BUILDING COMPLETION REPORT

With reference to your letter no B.S.C 306/41
date 21-1-42, I have to return the plans after
complying with your requirements as under:-

With reference to your application dated **20th December 1941** with a plan for the proposed buildings/additions and alterations on plot No. **33** Survey Sheet No. **B.R.5, Bunder** Quarter I have to request you to comply with the following requirements:—

PLAN SHOWING THE PROPOSED BUILDING ON PLOT No 33. B.R.5.

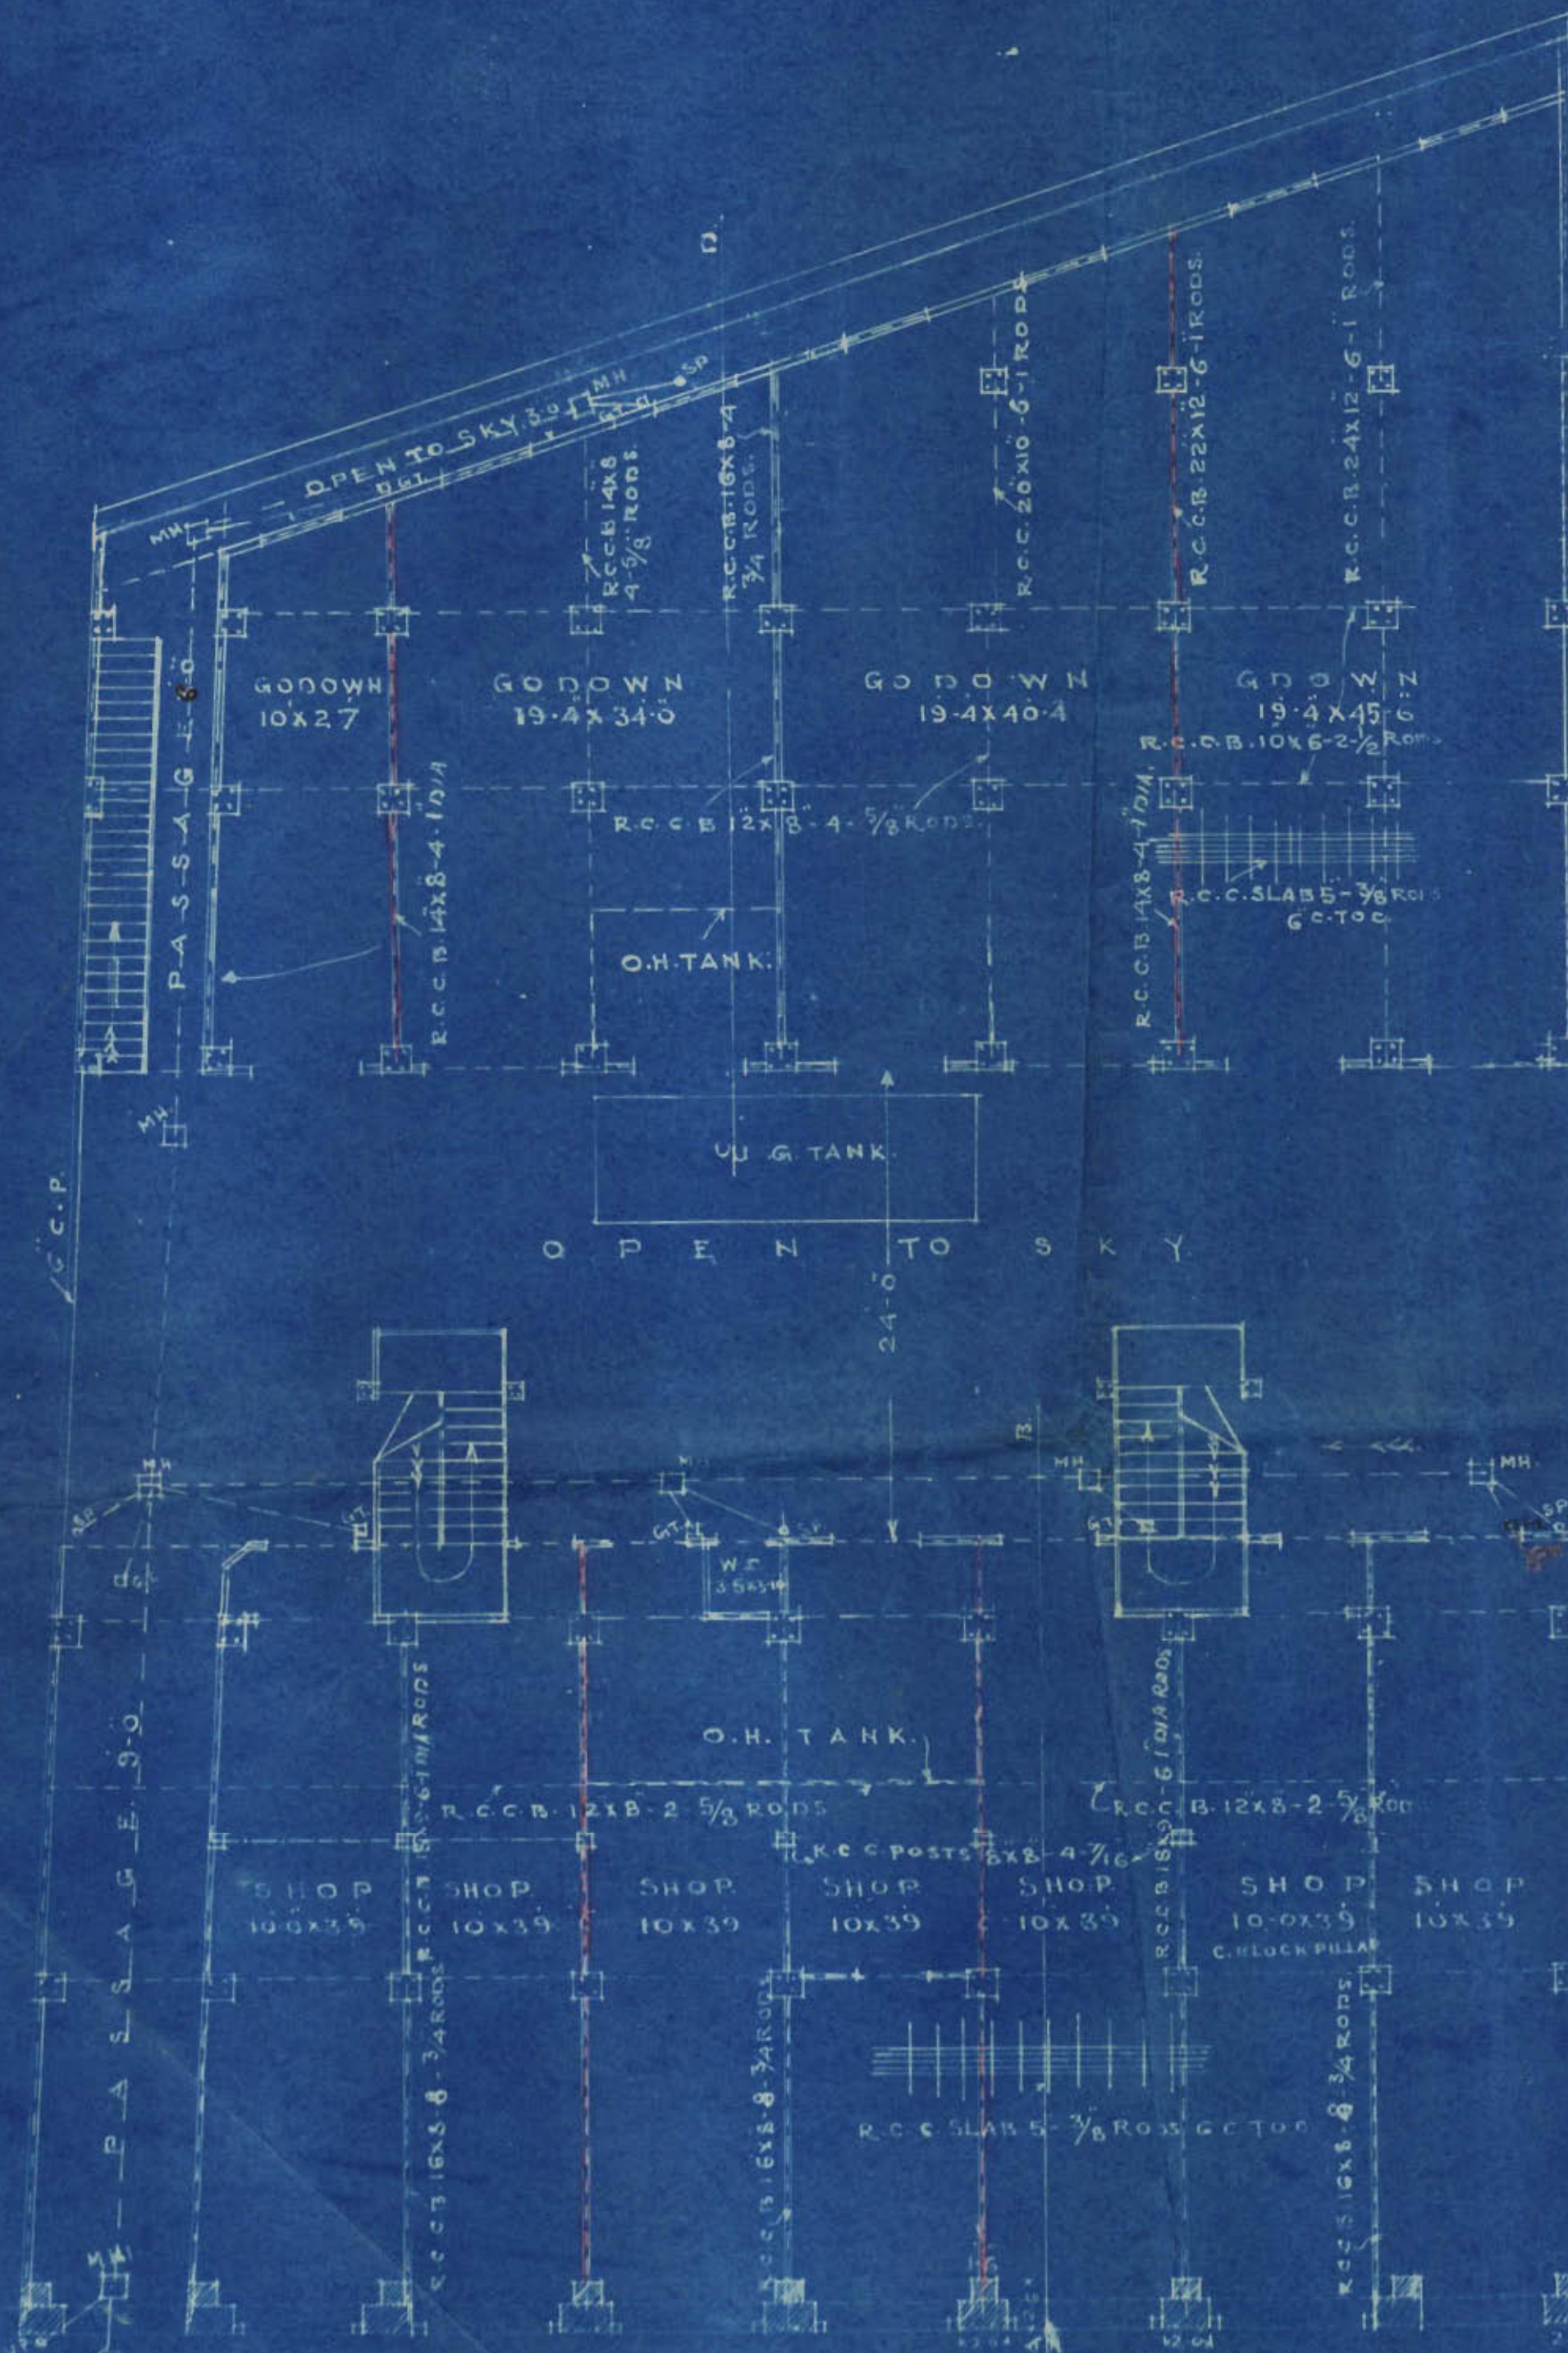
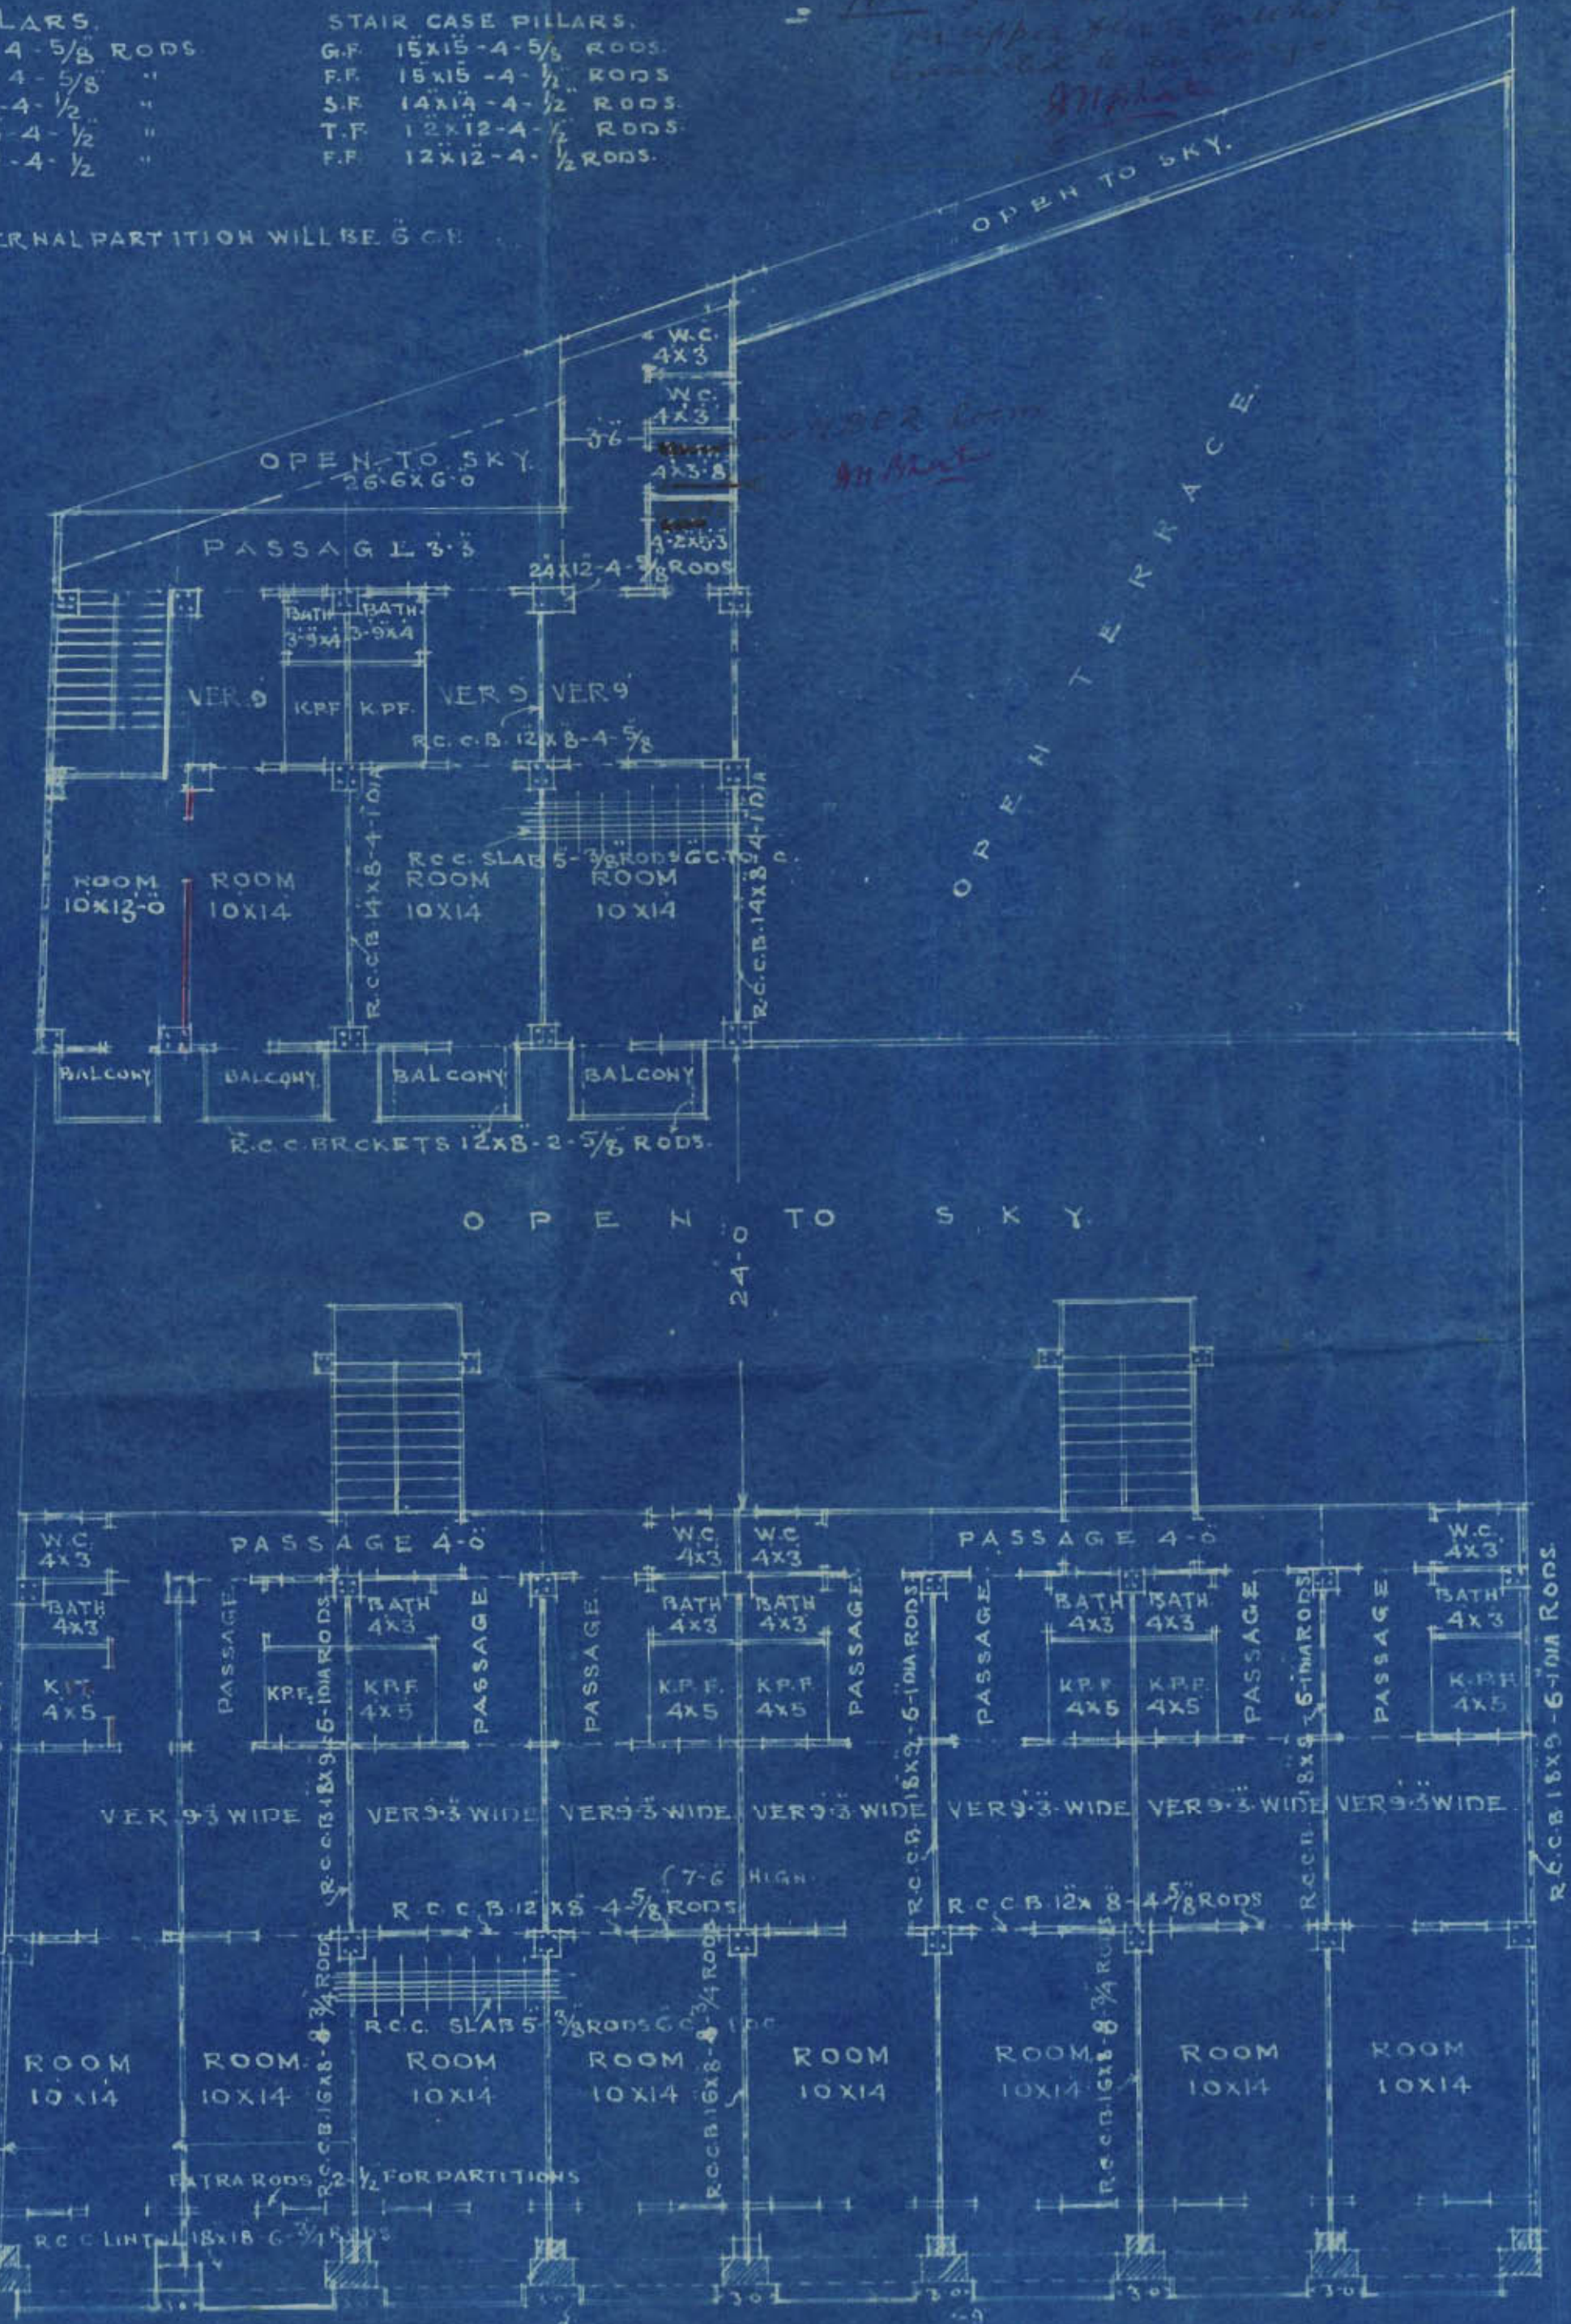
- (1) Please show how the baths and kitchens on upper floors in the rear block will be connected to drainage.
- (2) ~~Drainage~~ Amendments must be coloured red when the plans will be further considered.

- (3) Partition in the shop cannot be allowed.
- (4) The external partitions are ~~42~~ 32" with plaster which cannot be allowed.

1. Partitions in the shop cannot be allowed
2. The external partitions are $3\frac{1}{2}$ " with plaster which cannot be allowed

(1) Please show me the plan of the building as
upper floor is the last floor and is
connected to the ground floor by a staircase
which is closed and when the plan is
for further construction.

1) The arrangement for connecting both & between
in the new block is shown on the plan.

2) There is no special amendment. However
the new block drainage lines have been
coloured red.

3) Partitions in the shops have been provided
for giving a stone to the shop which is
lighted from the external open space
to which there should be no obstacle.

4) The external partition is required for external
wall in the new rules are 4" & 4" Even
brickwork which is only 2 to 2 1/2 inch work
have not been sufficient. There are no walls
for stone masonry & not for heavy masonry. The partition
may please be waived.

(1) The proposed drainage
arrangement for bath
& kitchen on upper floor
in the rear block & there
can not be allowed.

(2) All amendments
major or minor must
be cleared first as we
are coming over shops
& stores for which C.O.
sanction is necessary.
The B. Plan file No. 10 of 1941
is returned herewith pl.
